TECHNICAL NOTE

Job Name: Stag Brewery
Job No: 38262
Note No: TN038
Date: October 2022
Prepared By: O Akpengbe
Reviewed By: Greg Callaghan
Subject: Response to LBRuT on Temporary Use Application for Stag Brewery Site

Figure 1: Location Proposed Cycle Store (Drawing Ref: 38262/5501/145/E)

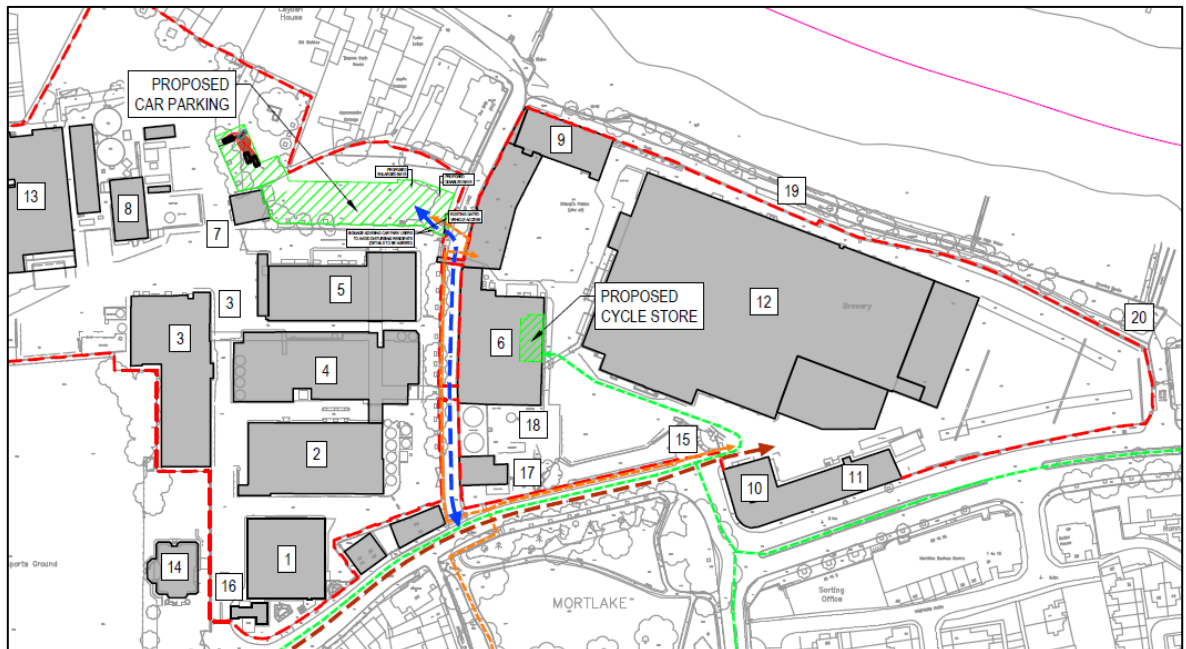
“The scheme proposes a cycle store in a building to the east of Ship Lane. Provide a floor plan, showing cycle layout / access / capacity / increased provision.”

- 2.6. The cycle store is proposed to be provided on site within Building 6 as shown in Figure 1. There is spare capacity within the proposed cycle store, for the number of Sheffield stands to be extended as shown below in Figure 2, therefore the number of cycle parking spaces could be increased upon future demand.

Figure 2: Proposed Cycle Store (Provided by Squire & Partners, Drawing Ref: JA12_Z0_P_00_010/A)

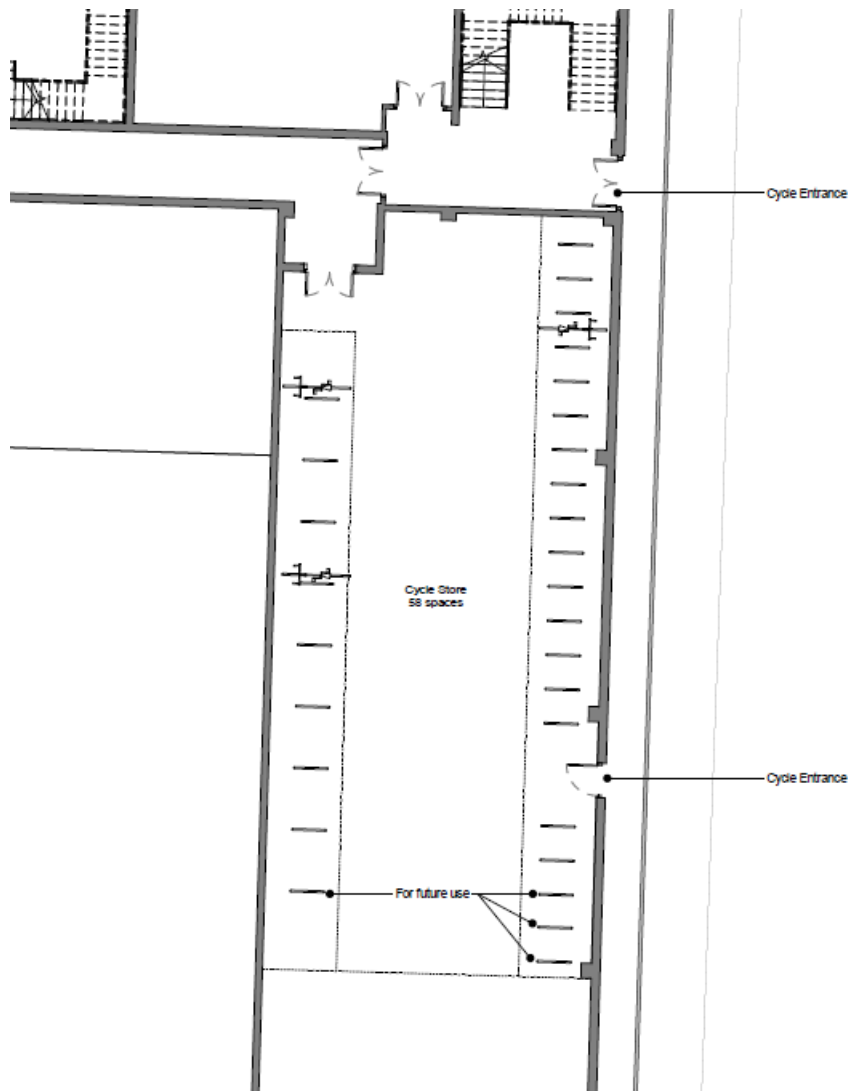
“state how many long stay and short stay cycle spaces will be provided”

“provide more details on the type of cycle parking stands the development will use, in line with the London Cycle Design Standards (LCDS), Sheffield stands are recommended.”

“demonstrate how cycle spaces will cater for larger cycles in line with Policy T5.”

“demonstrate how cycle parking provision could be increased upon future demand – to meet the Travel Plan targets (reduction in the number of private cars on site by 18%)”

- 2.5. Cycle parking will be provided with the standards set out in the London Plan (2021) and London Cycling Design Standards (LCDS. 2016). In line with London Plan Policy T5, Table 10.2, this development is classed as sui generis which requires a minimum of 25 long stay and 25 short stay cycle parking spaces. Therefore this scheme proposes to provide 25 long stay and 25 short stay cycle parking spaces. All cycle parking spaces are proposed to be provided as Sheffield stands including 16 spaced at 1.8m for oversized and accessible cycle parking in accordance with Policy T5 of the London Plan.

- 2.7. Based on the targeted mode shares as discussed in the Travel Plan which aims for a 18% reduction in staff driving by car, a 16% increase in travel by bicycle would be required. Therefore, 8 more cycle spaces have been shown in the plan, as seen in Figure 2.

Figure 3: Proposed Temporary Car Parking (Drawing Ref: 38262/5501/145/E)

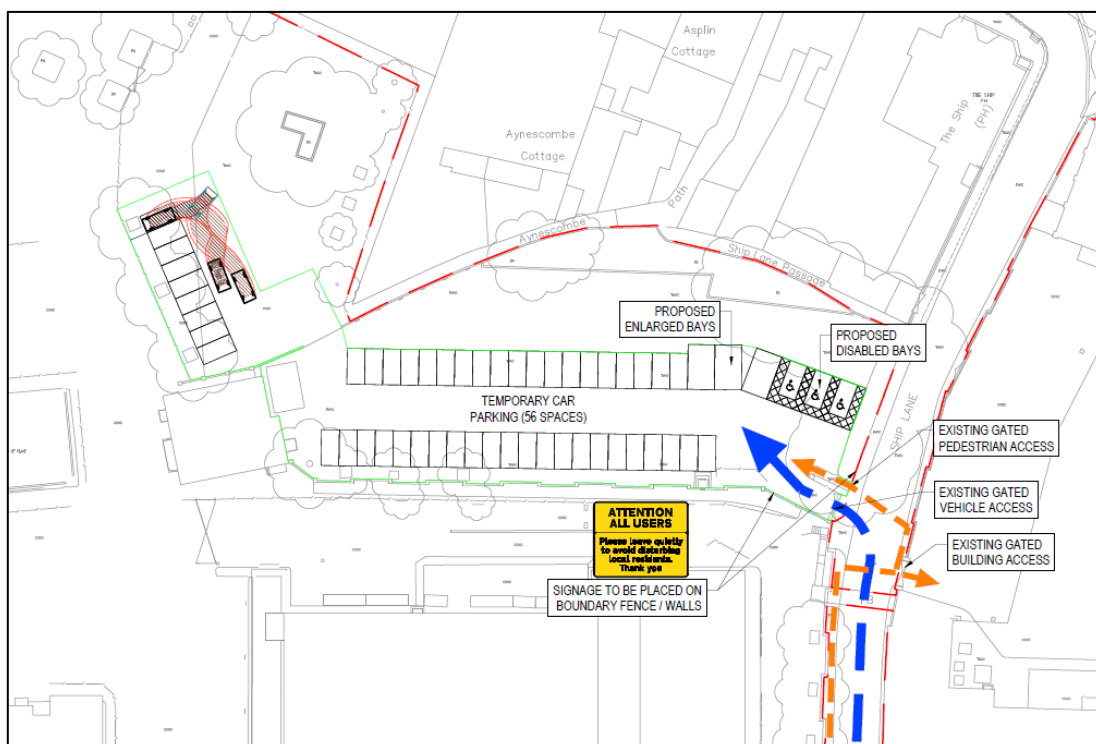
“the development should provide a minimum of 3 disabled persons’ car parking spaces and 3 enlarged bays. – Mark out where these will be provided.”

“Given the size of the existing car park, the scheme will clearly cater for the needs of the development, leaving opportunities to close off a section of the car park. Provide a plan demonstrating how the car park will be closed off to ensure residents are not unduly harmed through coming and goings.”

- 2.14. Furthermore, three disabled parking spaces and 3 enlarged bays have been shown in Figure 3 below. These are located adjacent to the entrance of the car park. A plan of the car park has been included in Appendix B (Drawing Ref: 38262/5501/145/E). This shows the location of the car park and the section adjacent residential properties to the on Thames Bank that will be closed off to reduce the impact on local residents.

Figure 4: Proposed Access Locations

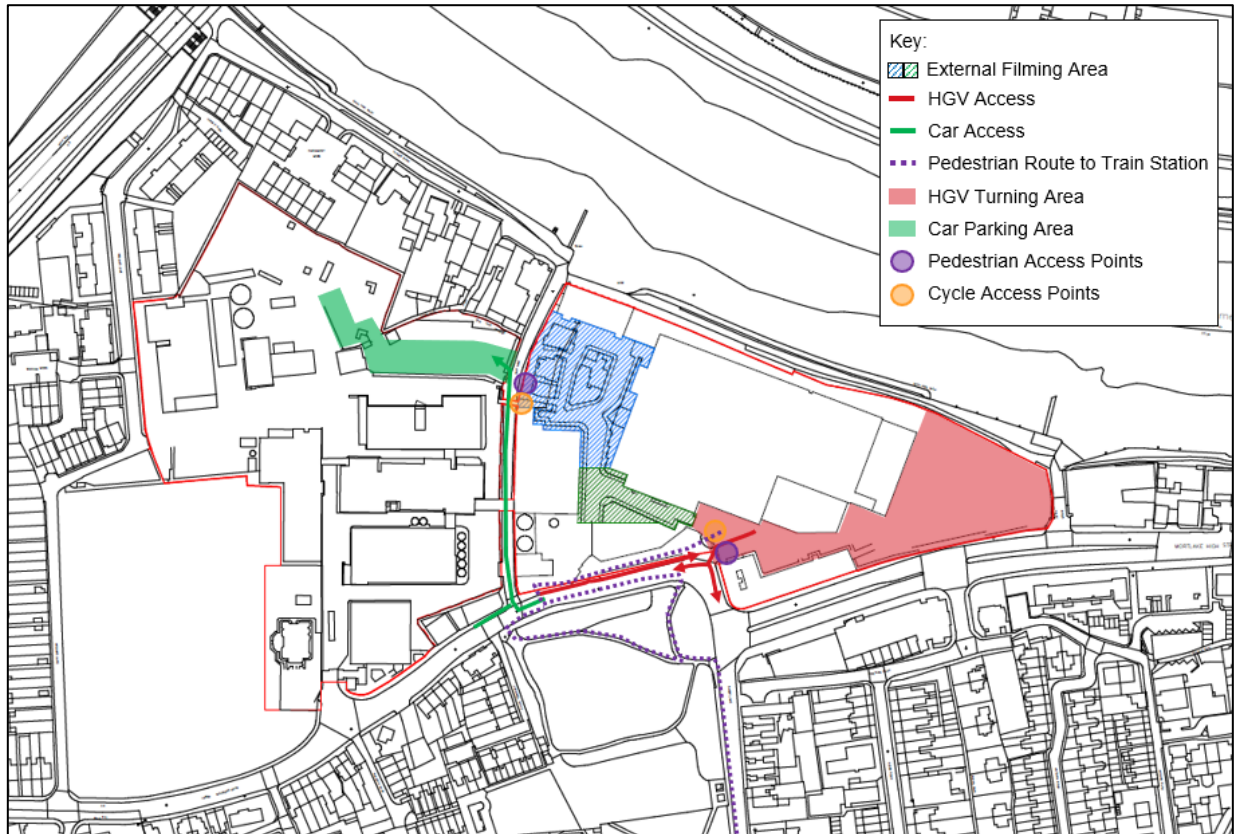
- 2.17. The comments in relation to access to the proposed development are as follows:
- “provide a detailed plan in relation to development access locations”*

- 2.18. A plan of the proposed access locations has been detailed in Figure 4 It is proposed to use the existing access points for the development. The vehicular access is proposed to be off Lower Richmond Road. This will also be shared with pedestrians and cyclists. There is also a secondary pedestrian and cycle on Ship Lane, opposite the access to the car parking area.

Figure 5: Pedestrian Routes to/from the Site

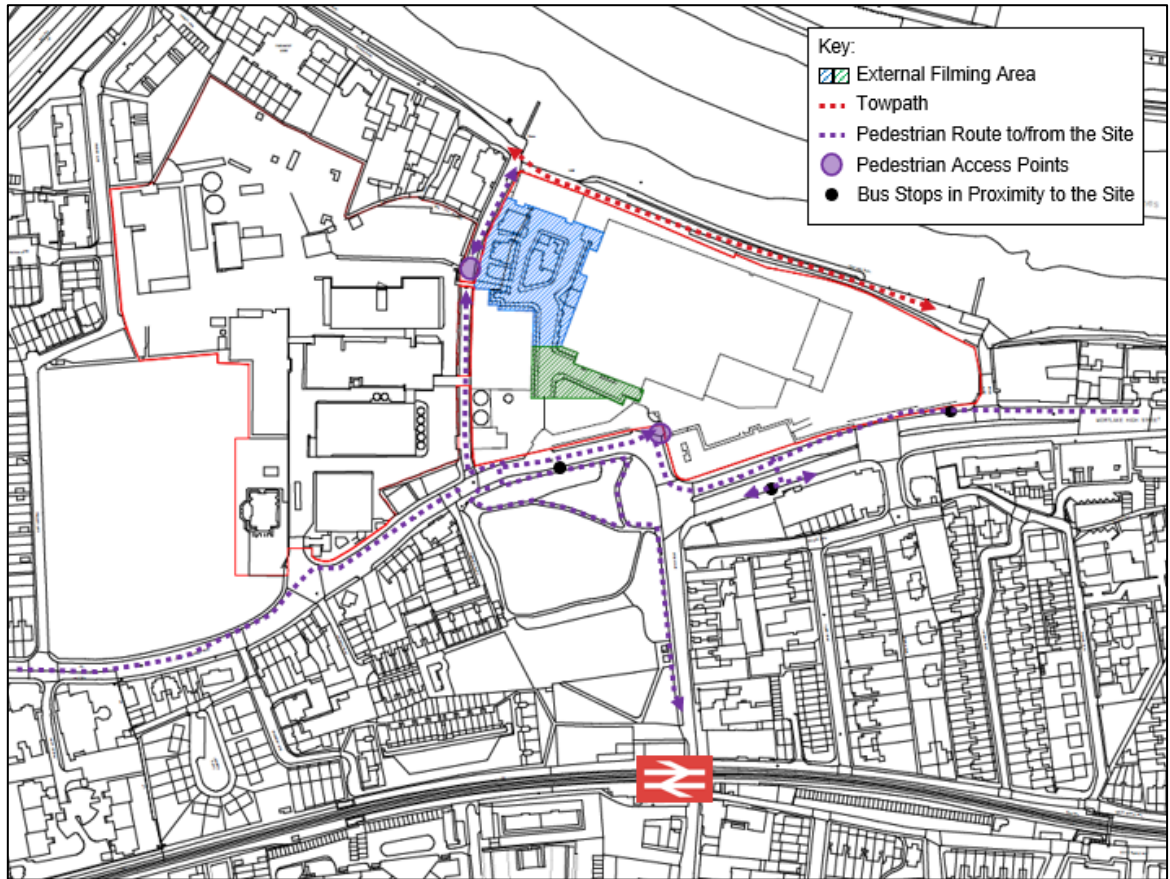
- “Provide further information to highlight pedestrian routes in and out of the site and the connections to the local amenities and how these pedestrian routes fit into the wider network of pedestrian pathways in accordance with Policy T2.”*

- 2.19. Furthermore, a plan showing pedestrian and cycle routes in and out of the site can be seen in Figure 5 and 6 respectively.

Figure 6: Cycle Routes to/from the Site

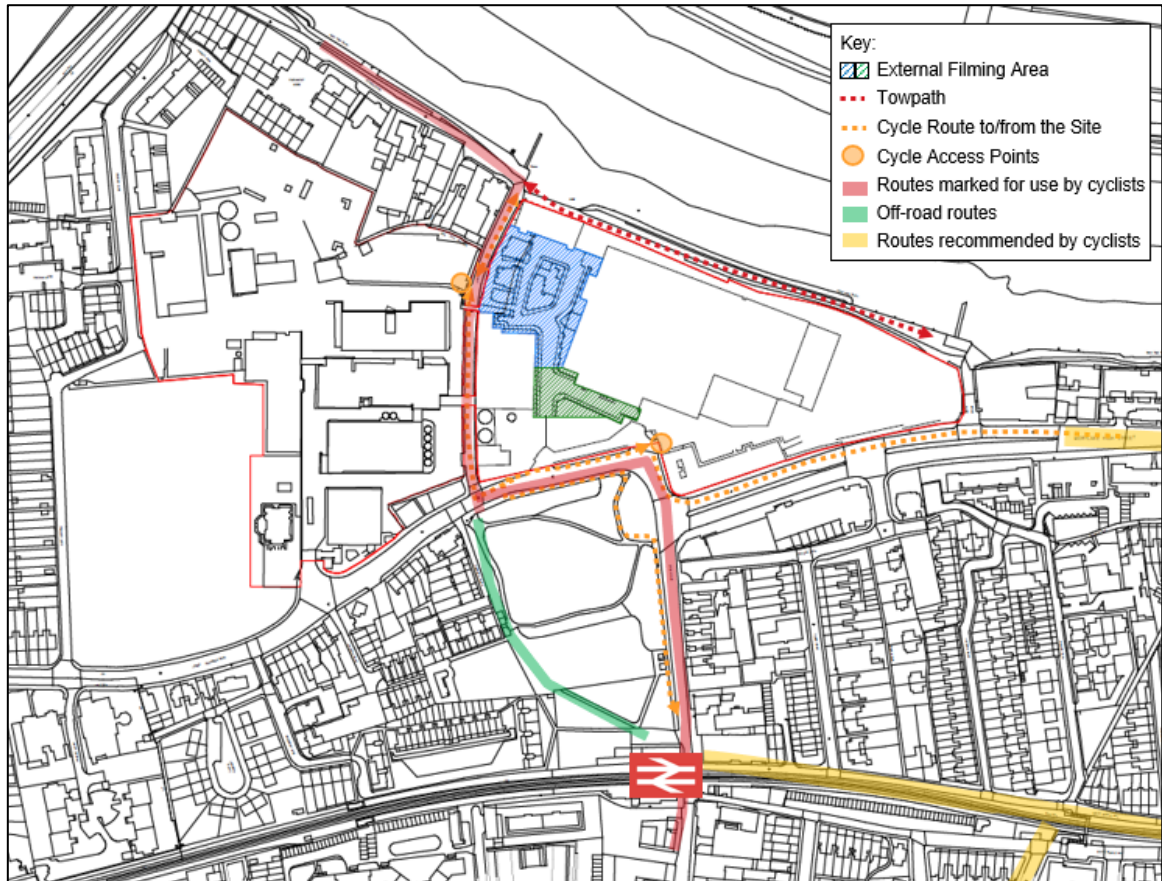
- “provide details about cycle access locations and cycle routes in and around the site and how these will fit into the wider cycle network in line with Policy T3 and T5.”*

Figure 7: Contingency Plan for Delivery and Servicing Vehicles Accessing the Site

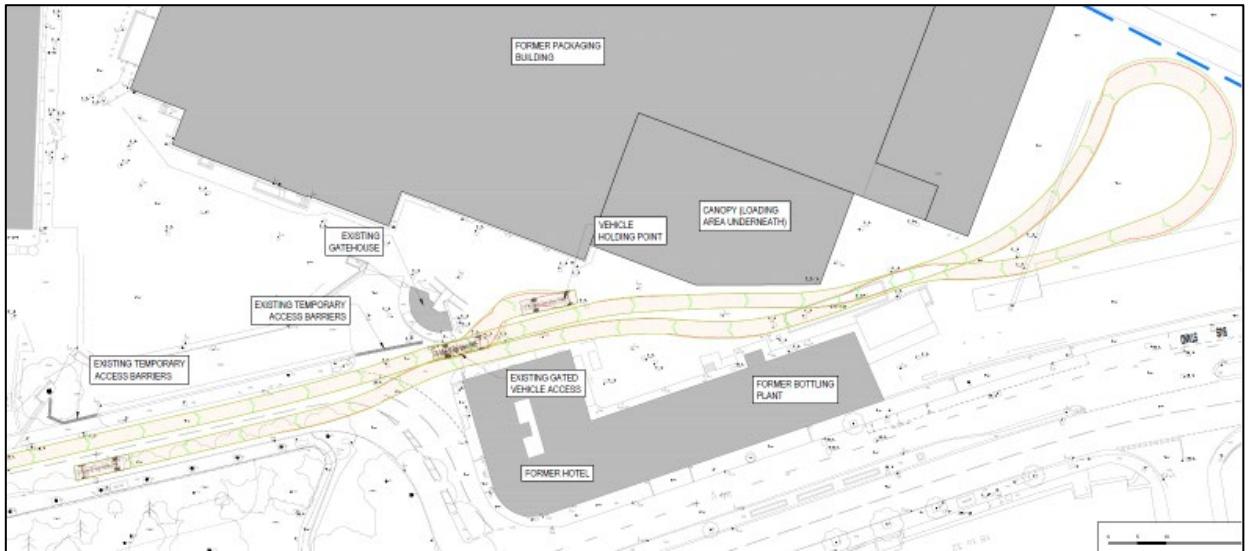
“highlight any contingency plans if delivery / service vehicles are not able to attend their booked spots.”

2.21. If vehicles are not able to attend their booked slots, vehicles can wait at the point shown in Figure 7 below. Vehicles will be able to wait past the existing gates until a slot becomes available to allow other vehicles past. A full plan has been included in Appendix C.

Figure 8: Potential Delivery and Servicing Routes

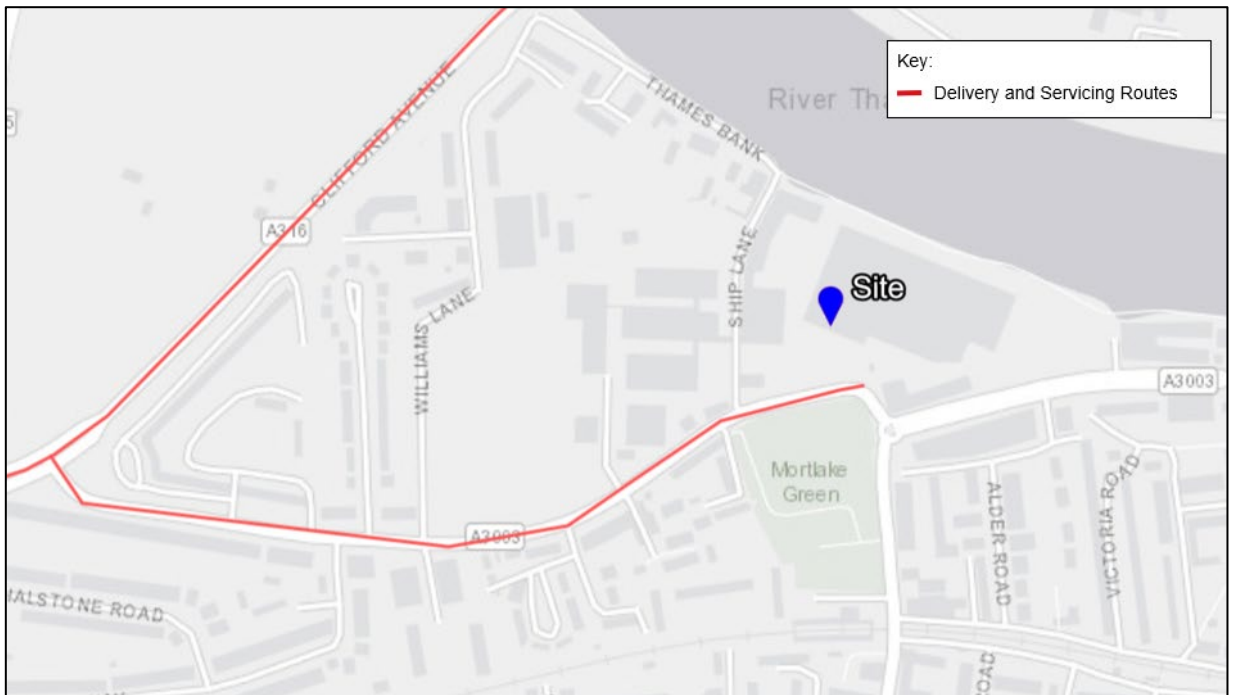
“Demonstrate which routes the delivery and servicing vehicles will use to enter and leave the site. If this is borough highway, a servicing strategy must be agreed with Richmond Council.”

- 2.22. The Site's entrance is located on Lower Richmond Road. Vehicles will come to the site via the Transport for London Road Network (TLRN) and then along Lower Richmond Road which is understood to be part of the LBRuT highway network as shown below in Figure 8. As demonstrated in the Transport Note, it is not expected that there will be any severe impacts from this scheme on the local transport network.

Figure 9: Proposed Waste Storage Area and Vehicle (Drawing Ref: 38262/5501/133/C and 38262/5501/152)

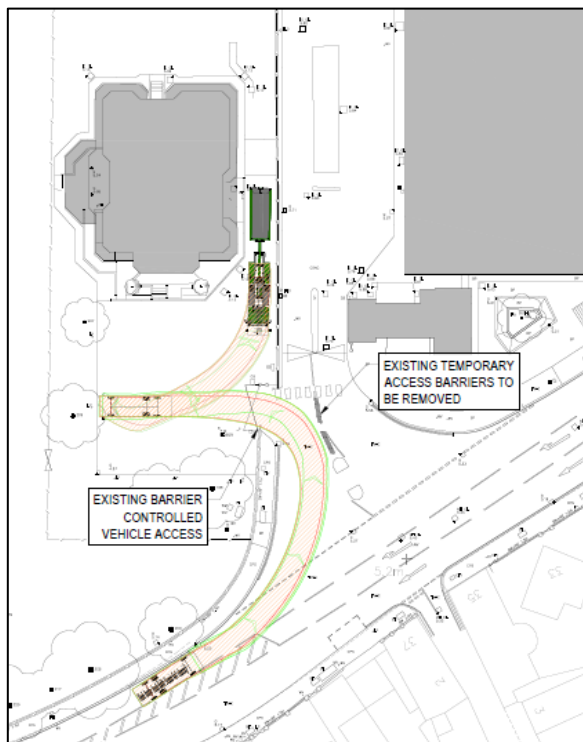
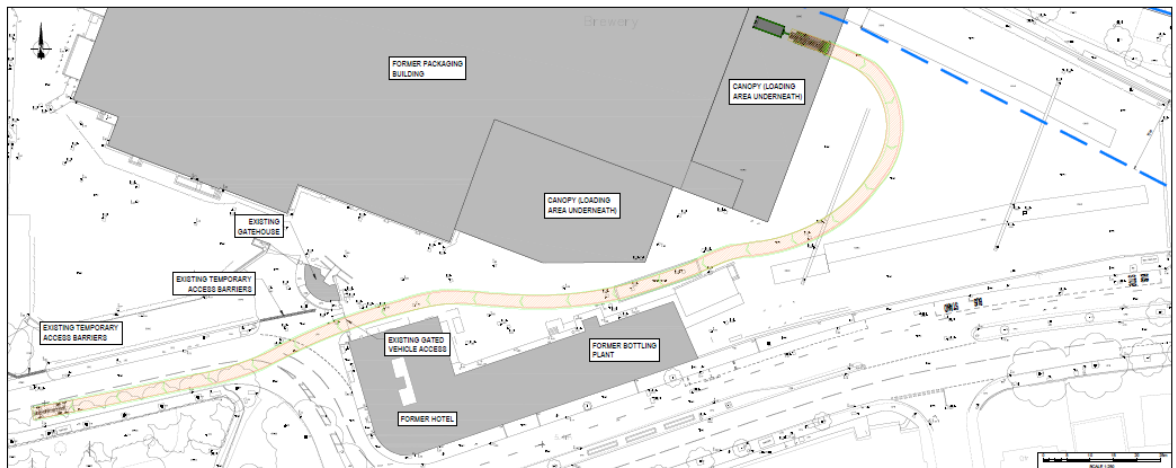
“With respect to waste, this is proposed to be stored in lockable skips / containers and collected by a private contractor on demand. The submission states exact location has yet to be determined, however, three potential locations have been identified outside turning areas. – provide the exact location about where waste stores will be; this should be off-street in line with Policy T7.”

2.25. The proposed locations of the waste store are east of Building 12 under the existing canopy and the car park area for the Sports Club.
